Report FL #: 10088 for Greenheck models EHH-601D & ESD-635D (both w/ and w/o VCD-40 Damper)

Report FL #: 10093 for Airolite models SCH601MD & K6746MD (both w/ and w/o VCD-40 Damper)

APPROVAL DOCUMENT: Drawing No. **K6746MD**, titled "K6746MD Louver", sheets 1 through 37 of 37, dated 08/09/2017, prepared by The Airolite Company, signed and sealed by Wayne K. Helmila, P.E. on 08/19/2024 and 09/27/2024, bearing the Miami-Dade County Product Control revision stamp with the Notice of Acceptance number and expiration date by the Miami-Dade County Product Control Section.

PRODUCT REVISED
as complying with the Florida
Building Code
NOA-No. **24-0930.05**
Expiration Date **12/06/2029**

AIROLITE SCHOFIELD, WISCONSIN 54476 715-359-6171	DRAWN BY MES	DATE 8/9/2017
	SCALE	
TITLE K6746MD LOUVER CONTINUOUS ANGLE MOUNT ELEVATION H≤144"	SHEET NO. 2 OF 37	
	CAD DRAWING NO. K6746MD

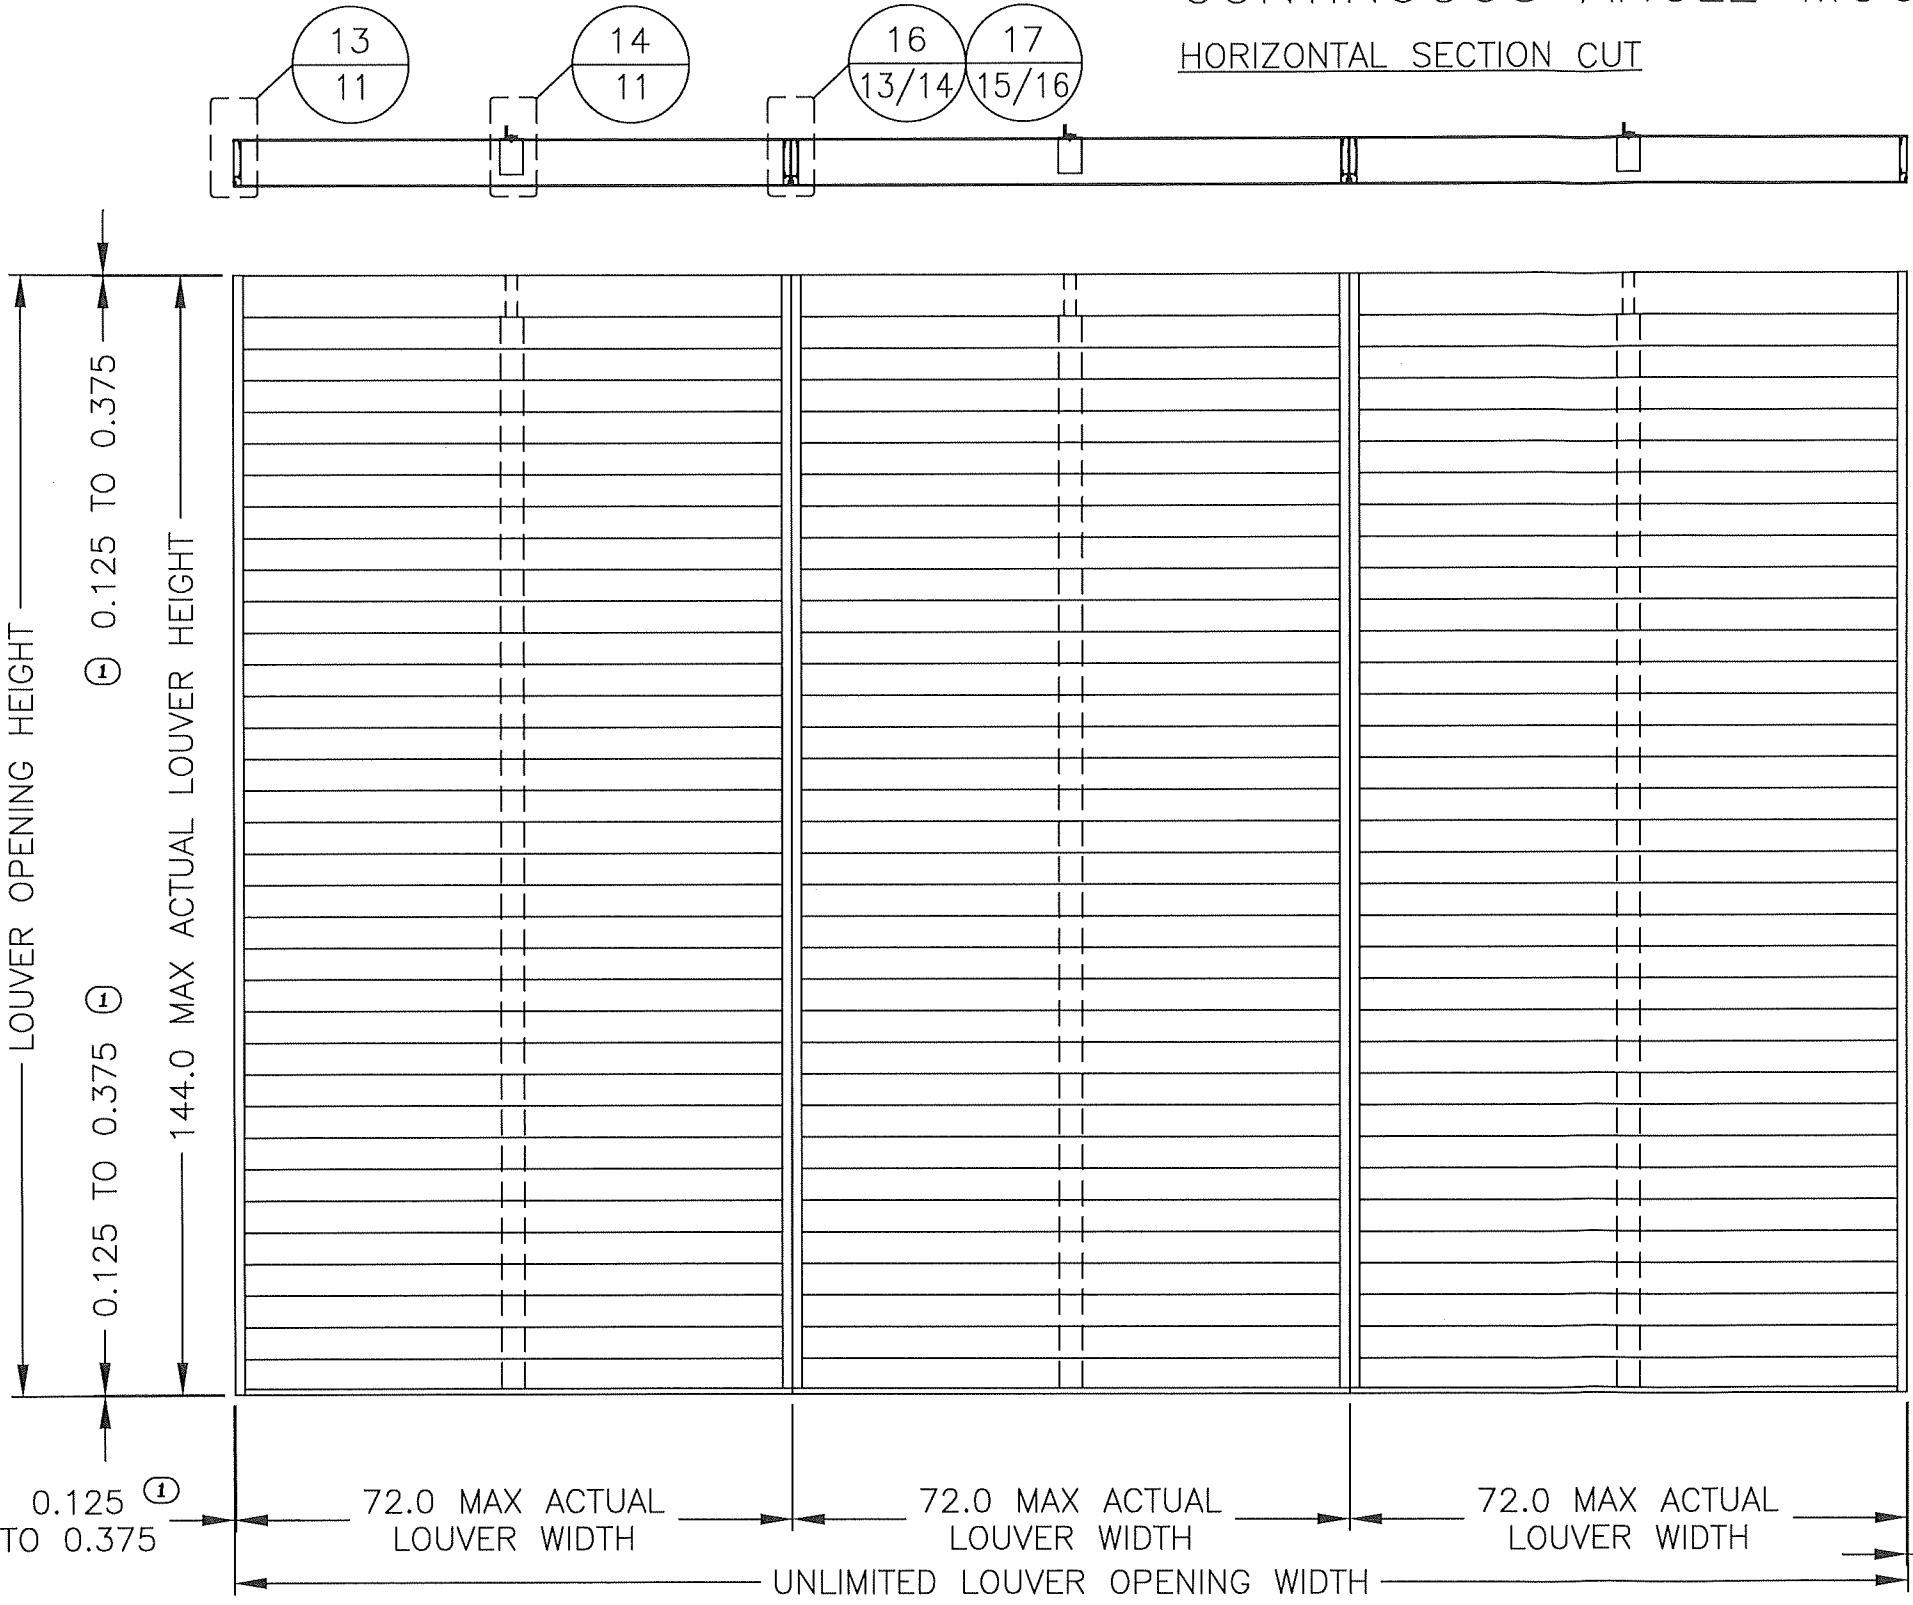
REV 01: 8/1/24, UPDATED TITLE BLOCK & DETAIL TITLES ON ALL PAGES AS NEEDED, UPDATED DETAIL CALLOUT PAGE NUMBERS AS NEEDED ON ALL PAGES, ADDED PRESSURE BOX, ADDED DETAIL CALLOUT NOTES, & REMOVED "TYP" FROM EDGE GAP X4.

AIROLITE SCHOFIELD, WISCONSIN 54476 715-359-6171	DRAWN BY MES	DATE 8/9/2017
	SCALE	
TITLE K6746MD LOUVER W/VCD-40 FLANGE FRAME SLEEVE MOUNT ELEVATION HS144"	SHEET NO. 3 OF 37	
	CAD DRAWING NO. K6746MD

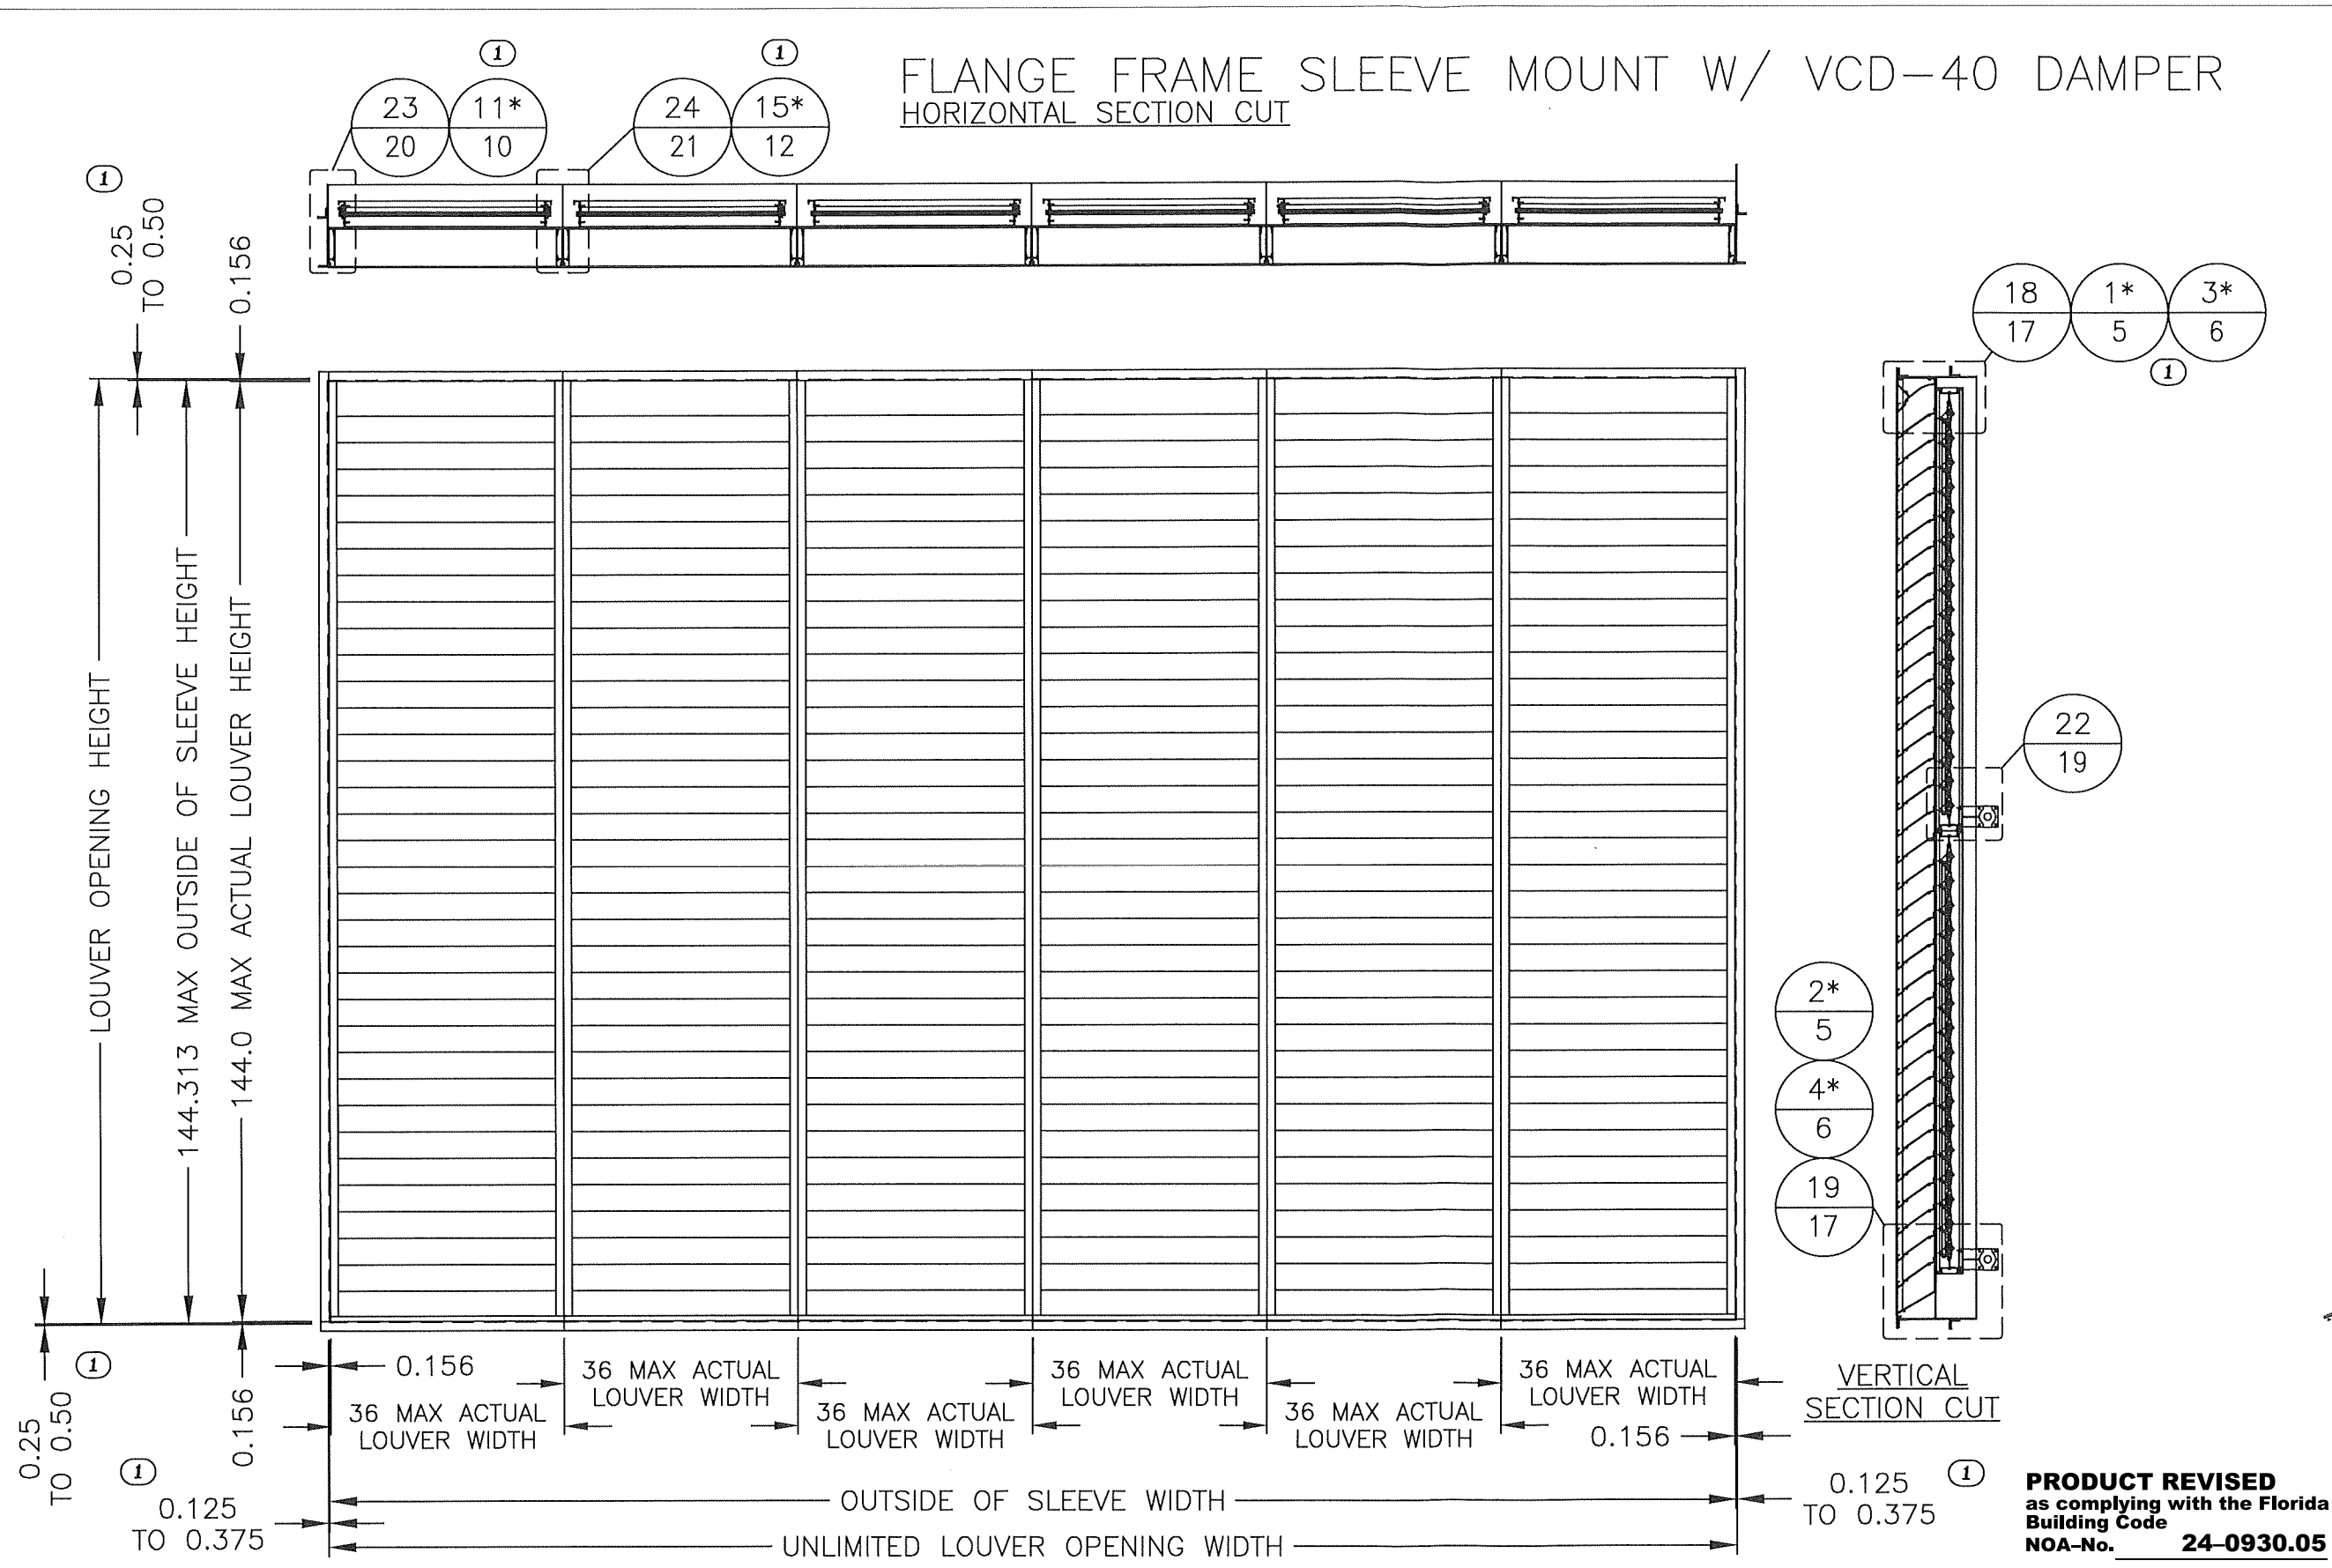
REV 01: 8/1/24, REMOVED "TYP" FROM EDGE GAP X4, ADDED DETAIL CALLOUTS 1/2/3/4/11/15, & ADDED ASTERISK NOTE.

AIROLITE SCHOFIELD, WISCONSIN 54476 715-359-6171	DRAWN BY MES	DATE 8/9/2017
	SCALE	
TITLE K6746MD LOUVER W/VCD-40 CONTINUOUS ANGLE MOUNT ELEVATION HS144"		SHEET NO. 4 OF 37
		CAD DRAWING NO. K6746MD

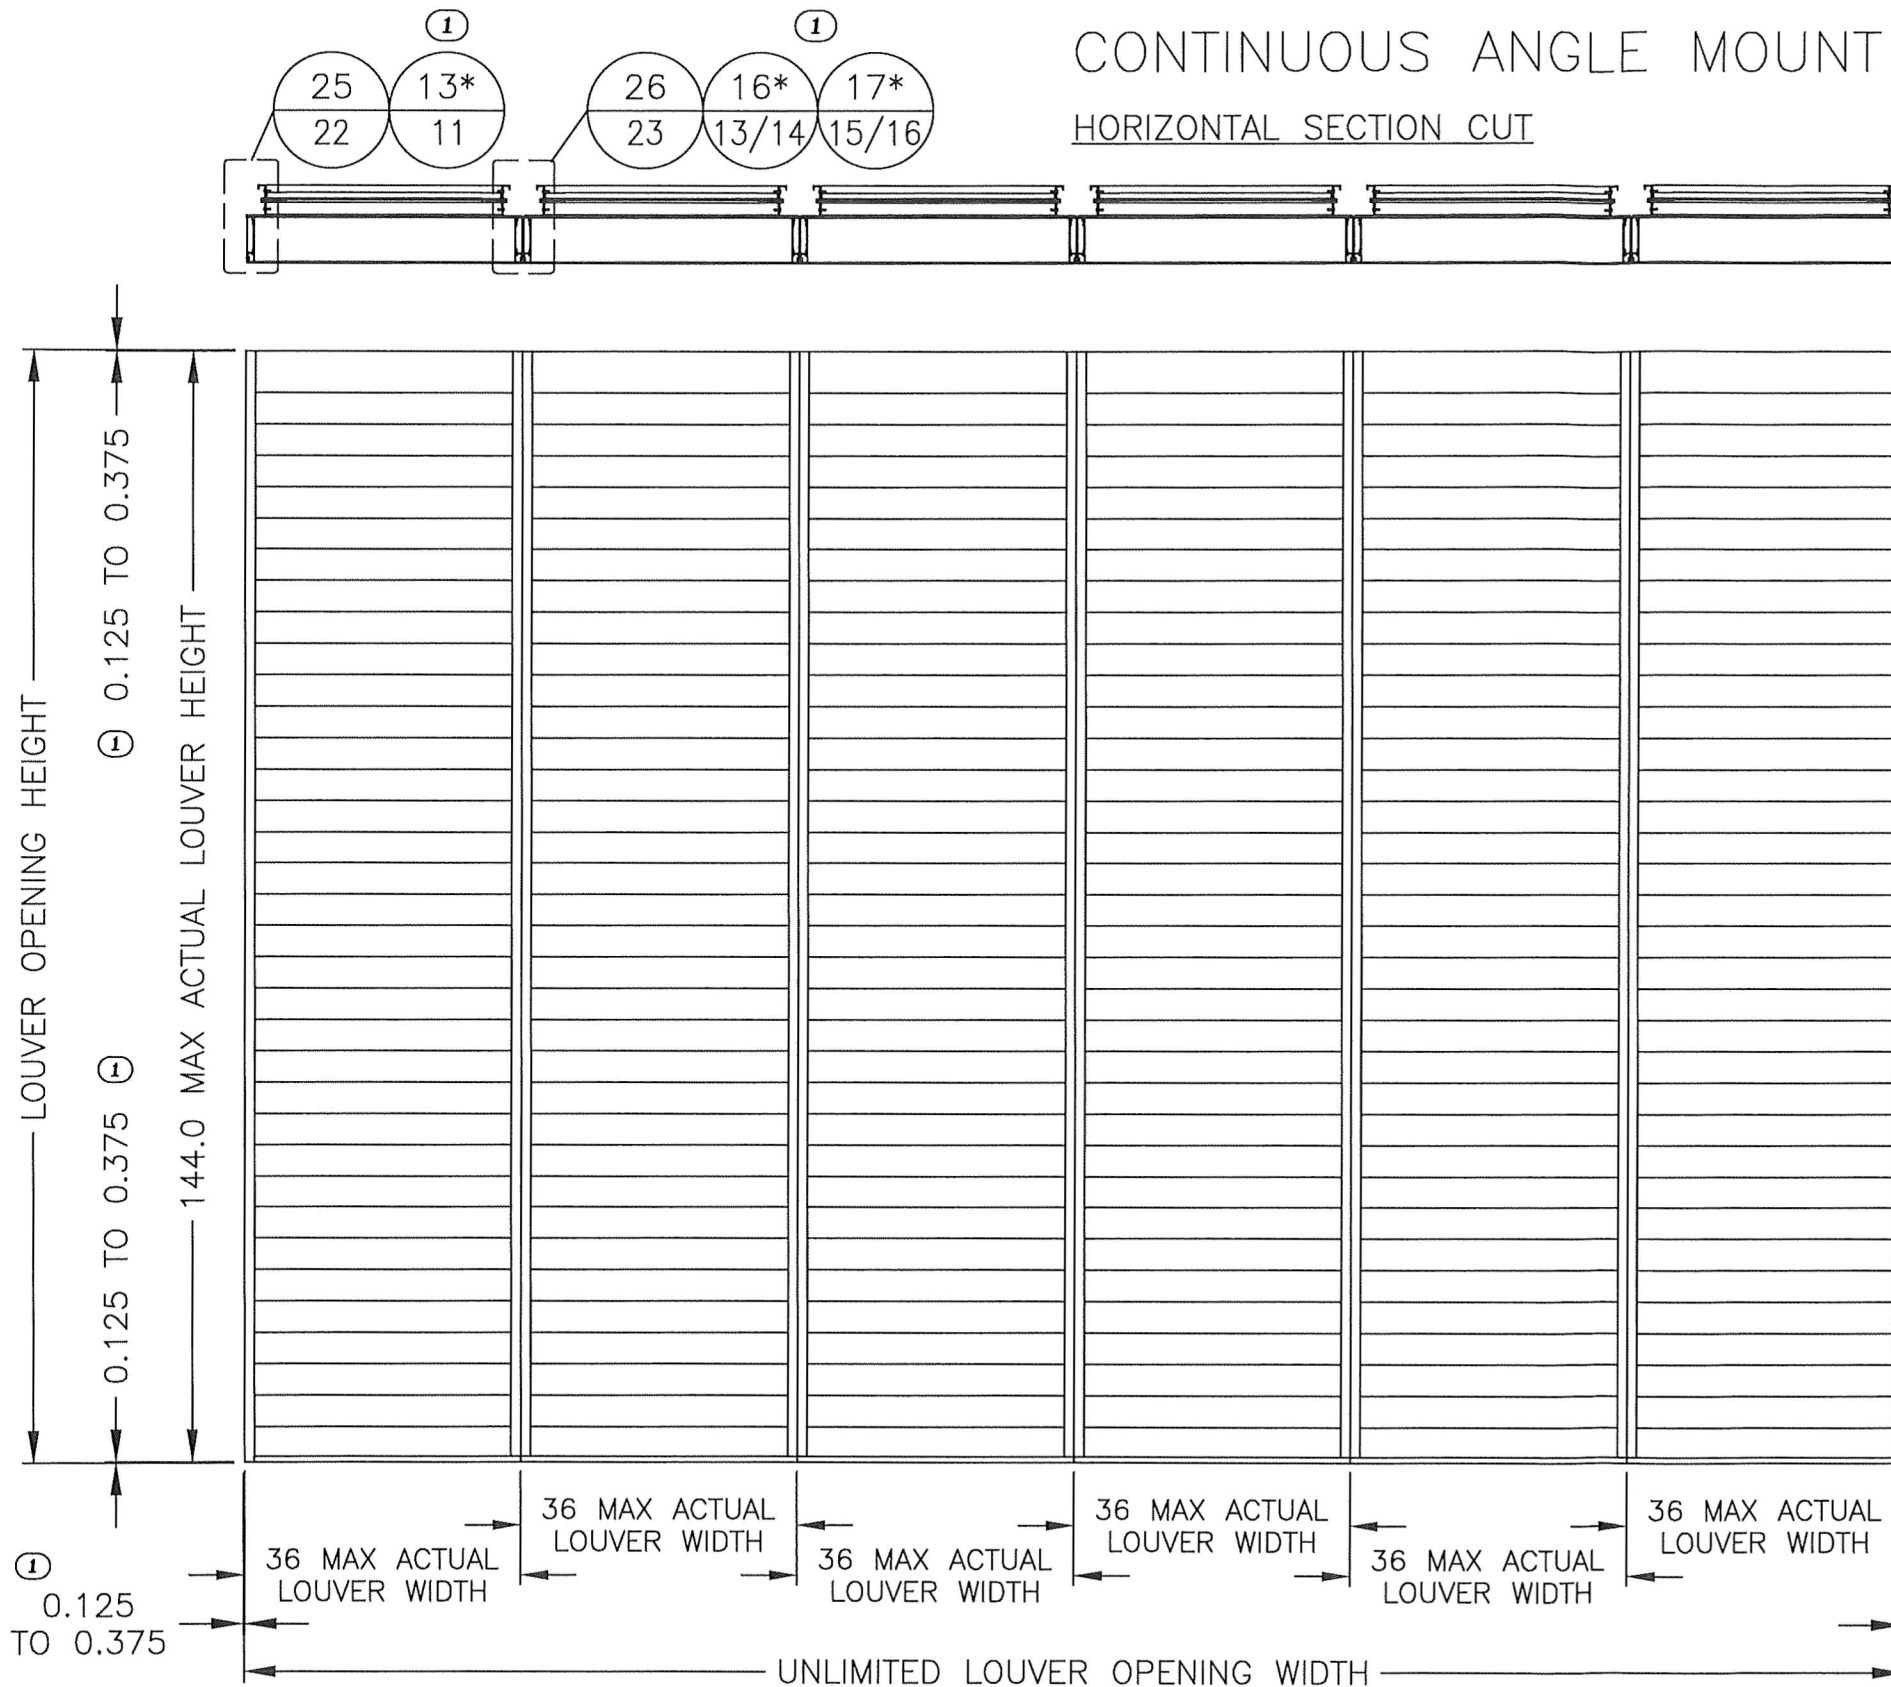
REV 01: 8/1/24, REMOVED "TYP" FROM EDGE GAP X4, & ADDED DETAIL CALLOUTS 5/6/7/8/13/16/17, & ADDED ASTERISK NOTE.
